MODIFICATION #4  
WEST LILAC ROAD  
(FROM THE WESTERLY ROUNDABOUT TO THE NORTHERLY BOUNDARY)  
**DEPARTMENT OF PUBLIC WORKS**

**Request for a  
Modification to a Road Standard  
and/or to Project Conditions**

Project Number: TM 5571/5572 Date of Request: January 31, 2014

# ATTACHMENT #1

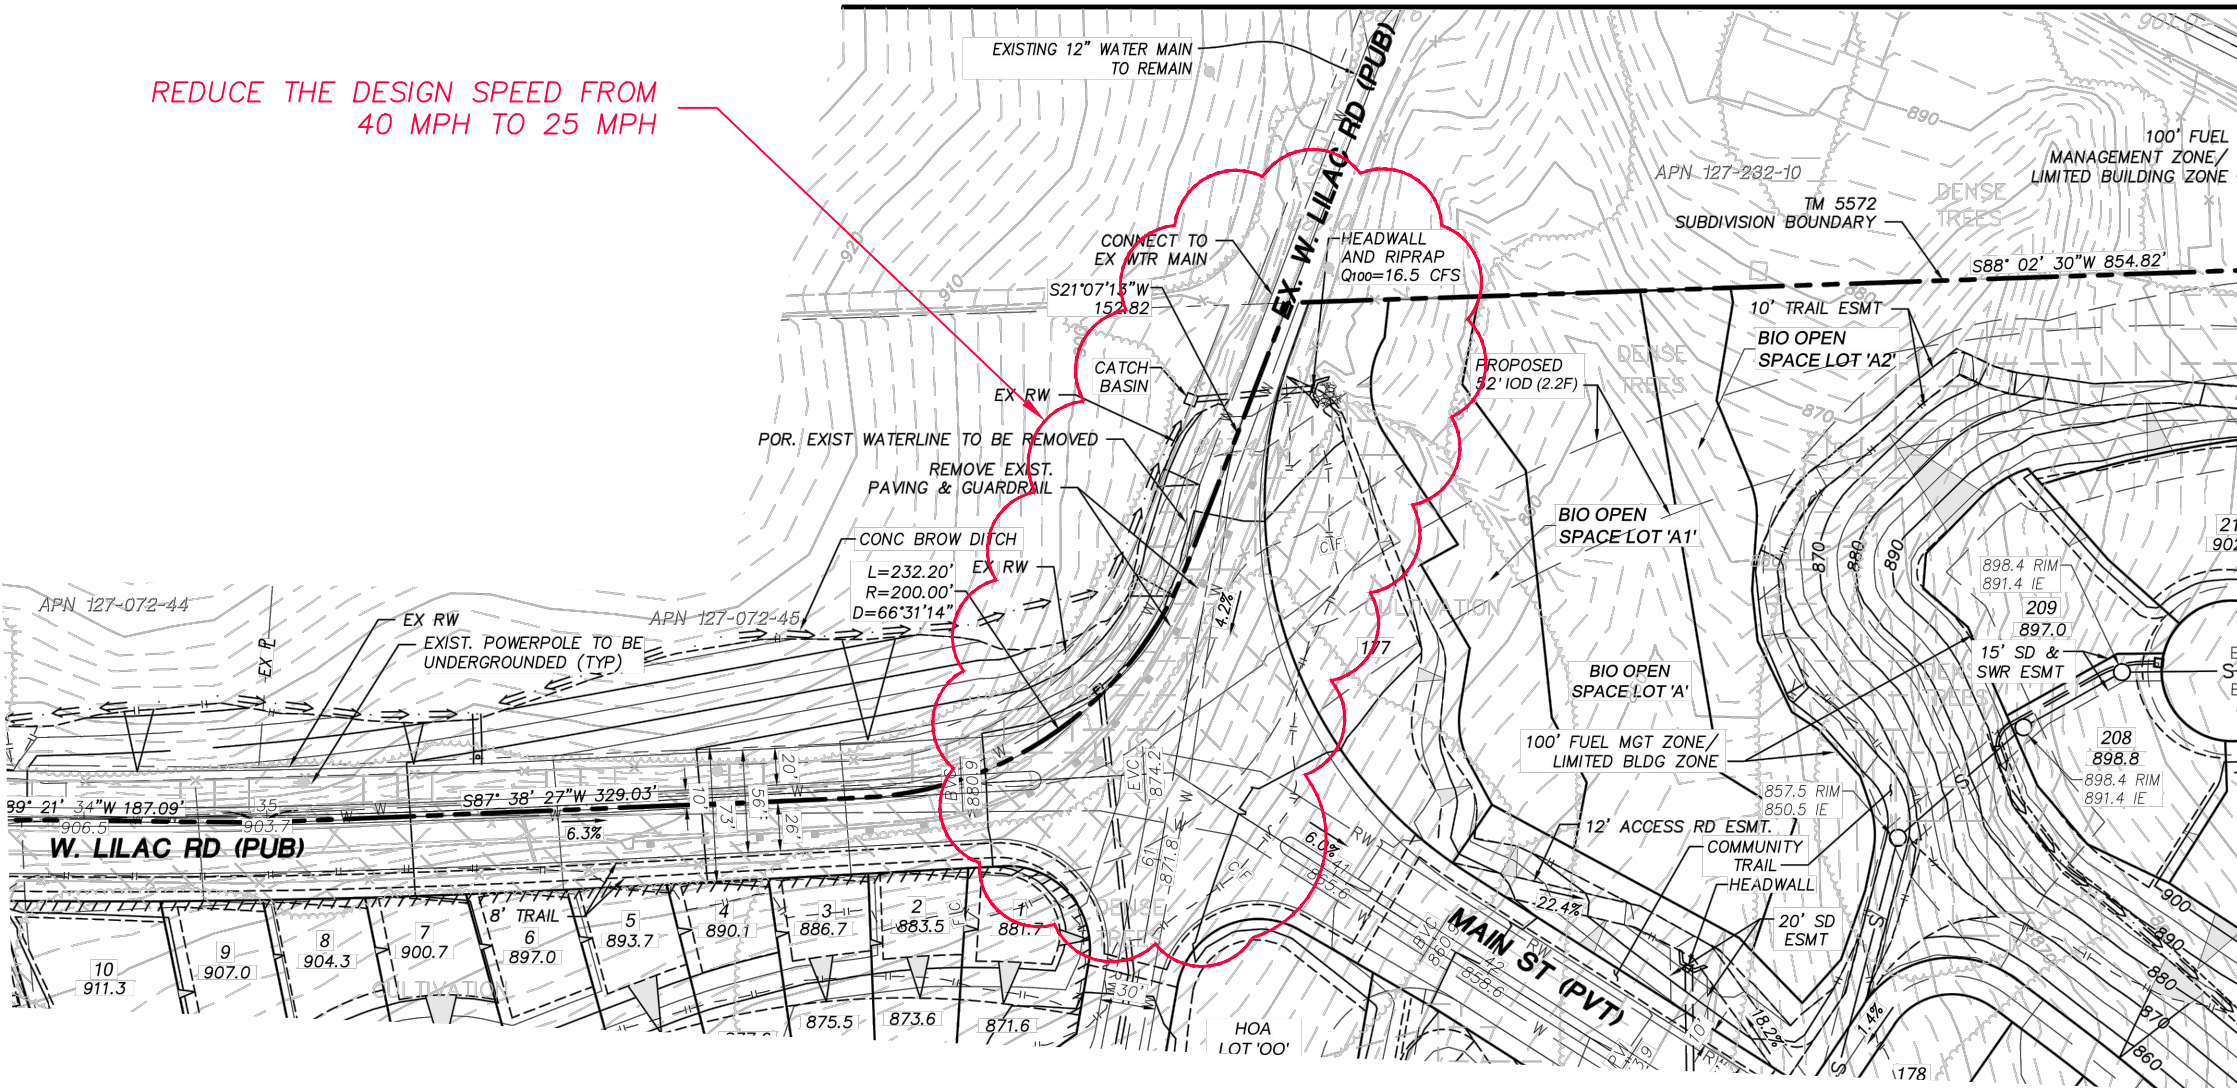
The standard road section for Light Collector 2.2F requires 28' road surfacing width,  
52' ROW, 2' shoulder, and 12' parkway, and a minimum design speed of 40 mph. The requested  
modification is to reduce the design speed to 25 mph and to reduce the road surfacing  
width to 24' with 28' graded width.

This 300' long portion of road is a transition from the onsite roundabout to the existing West Lilac Road.  
Without the transition, the actual length of full 2.2F width road that could be constructed is only 70' long,  
due to the transition from the roundabout and to existing West Lilac Road. Likewise, Increasing the design  
speed on this short piece of existing road to 40 mph will require making the proposed road alignment longer to  
accommodate the necessary vertical curve, thus increasing offsite grading and biological impacts and requiring  
offsite ROW acquisition. The projected ADT for this segment of roadway is very low, which the slower design  
speed could easily accommodate. Additionally, it is desirable to reduce the speed of traffic in a roundabout  
approach to increase safety and roundabout performance. This request also maintains consistency with existing  
road characteristics and geometrics

Increasing the design speed will require a new vertical curve design in a constrained  
distance. In order to mitigate this, the alignment will have to be lengthened, thus affecting  
adjacent property owners by means of increasing offsite grading, biological impacts, and requiring  
offsite ROW condemnation.
